Final (#4) Preliminary Environmental Assessment of Proposed Katherine Johnson Middle School 2641 Kent Drive Sacramento, California

San Juan Unified School District

Project Number: 60682851

Revised September 20, 2023

SITE PLAN & SAMPLE LOCATIONS

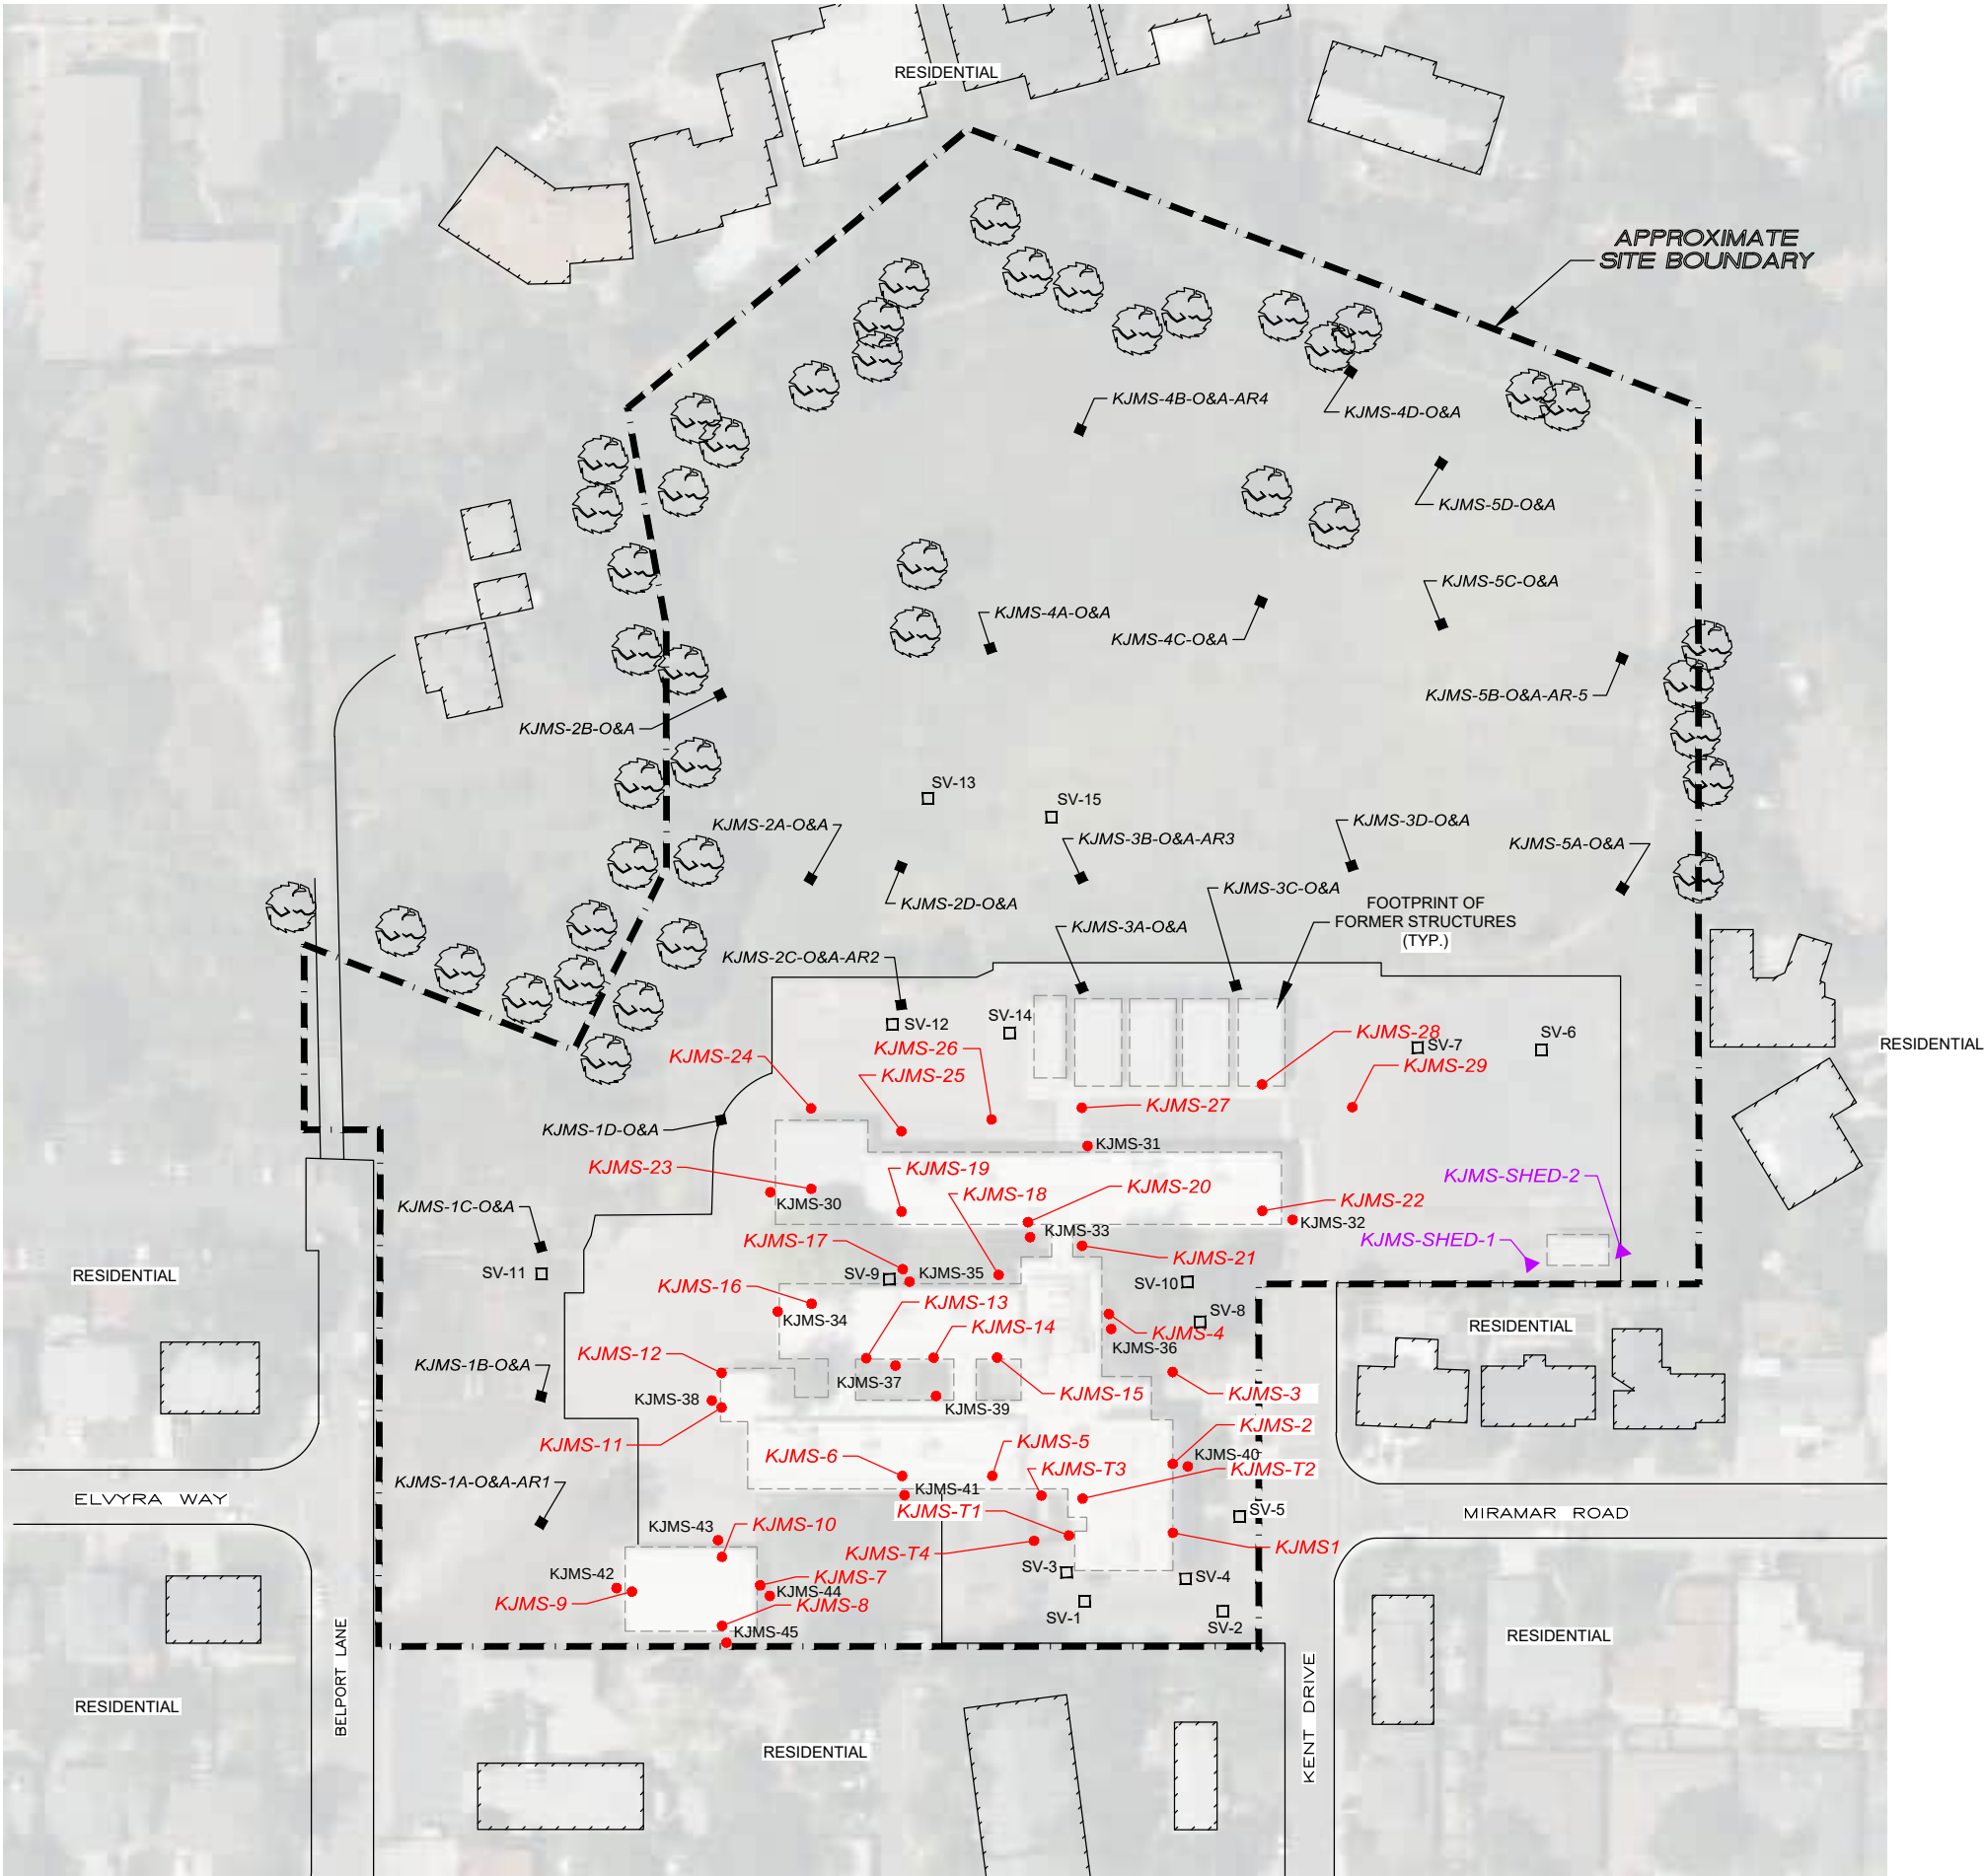
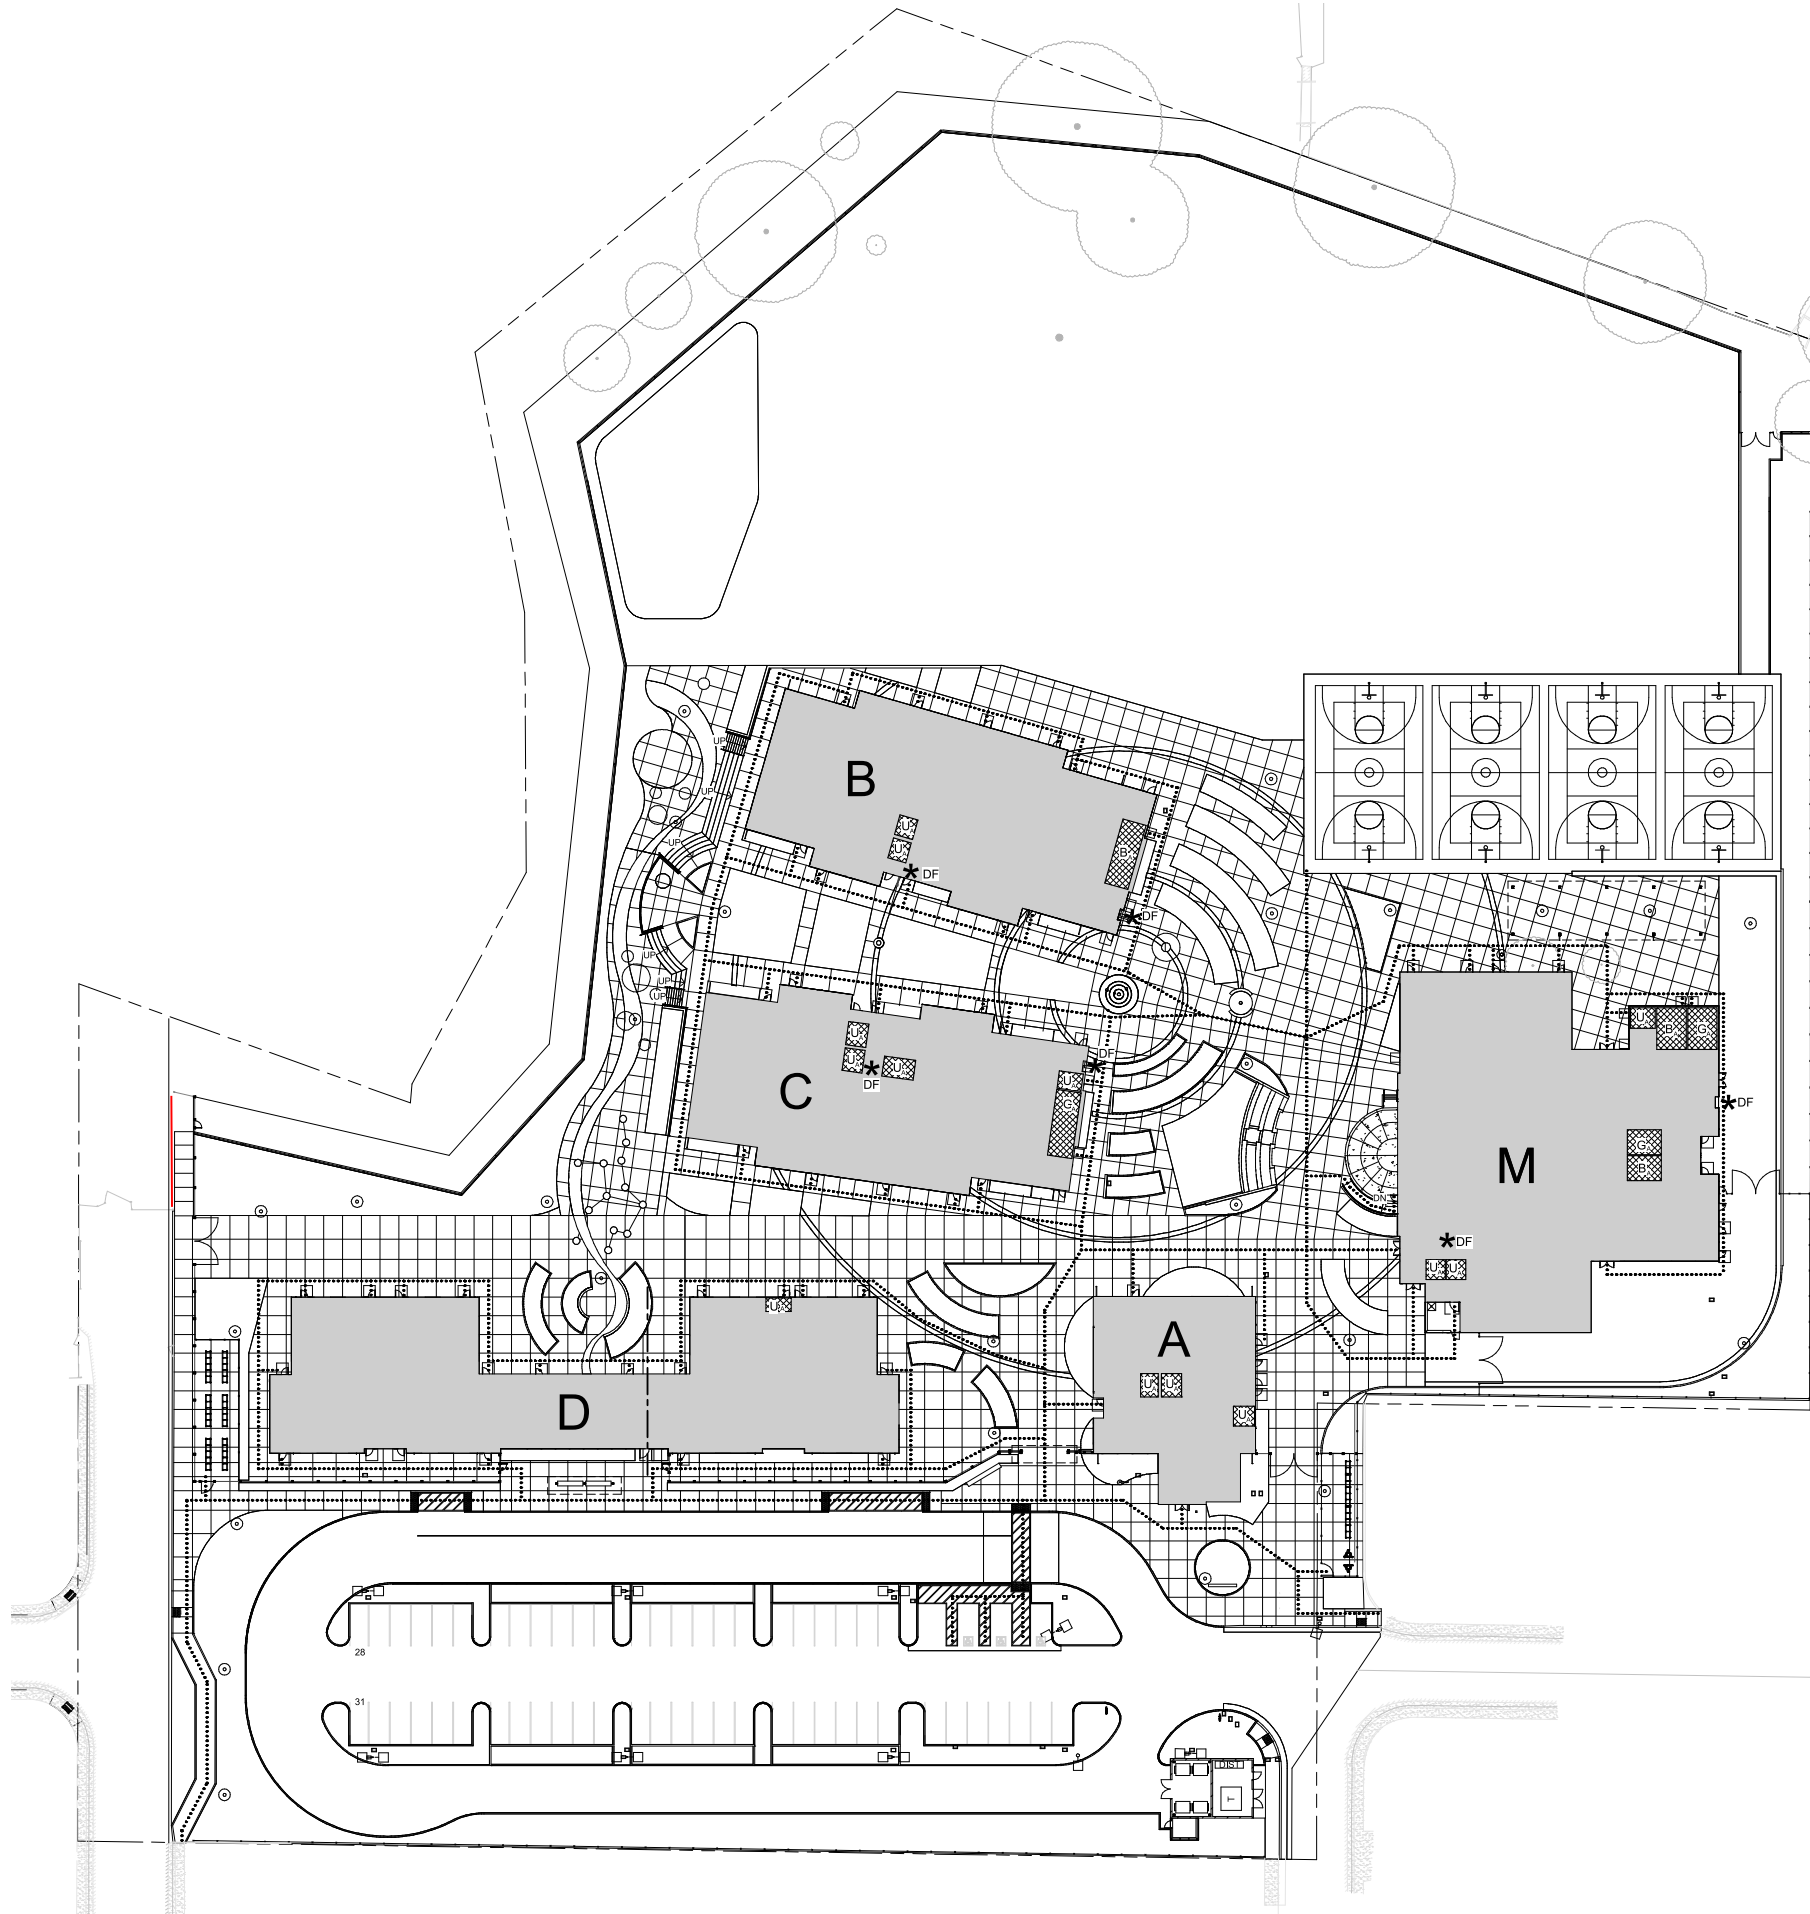
The Draft PEA indicates multiple soil test locations shown inside EXISTING building footprints (i.e., KJMS-19, KJMS-6, KJMS-5) or in areas covered with hardscape (i.e., KJMS-27, KJMS-29, KJMS-T3, KJMS-T1). (See, Atlas Report, Figure 2 – Site Plan and Sample Locations.) The Report fails to indicate the method(s) used to penetrate EXISTING building slab on grade or foundations to reach sample area (e.g., coring?). The report further fails to identify the method used to determine whether material(s) tested were in situ materials or building base materials or artificial fill. This information is important to properly and fully characterize the site and to protect the safety of children and adults who will be at the school once constructed and the neighborhood in which the school will operate.

The Draft PEA indicates that arsenic was located near the surface across the majority of the campus. (see, Figure 1 – Site Plan and Sample Locations) Arsenic was tested for and detected in five locations all at a depth of 0.5 to 1.5 feet BGS. No additional testing was done at greater depths. No reason or rationale is provided for the failure to further test the site. The highest concentration was identified in areas that will not be surfaced and which will remain open to student contact. Given the limited testing, higher concentrations of arsenic at depth cannot be ruled out without additional testing at depth and in additional locations.
